Building Manager: [Blaine Ray Baker, bakerb@oregonstate.edu](mailto:bakerb@oregonstate.edu)
 Assessment Date: 4/19/2022
 Assessment Number: **10566**
 Location: Coastal Range Building (fka RWL) Entire
 Reinspection date:

A joint fire safety inspection of the facility listed above was performed by the Environmental Health & Safety - Fire and Life Safety and the Corvallis Fire Department. These fire safety deficiencies could result in a fire or jeopardize the safety of those occupying the facility. Please see that these items are corrected immediately and no later than the scheduled reinspection date noted with this report. If you have any questions regarding this inspection, please email Brian Lilley (EH&S - Fire and Life Safety) at brian.lilley@oregonstate.edu.

Near Room 1083

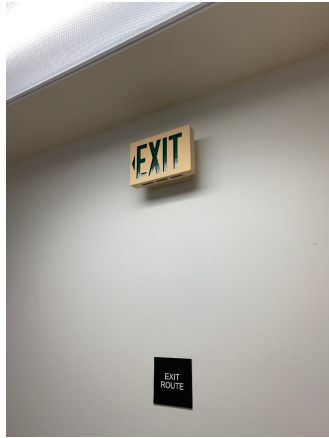
Priority code	Standard in need of attention	Reg.Reference	Location	Resp	Observations & Recommendations	Date Corrected
2	Emergency lighting shall be maintained.	2019 OFC 1031.10	1083:hallway near	FS	Exit sign does not provide illumination near room 1083.
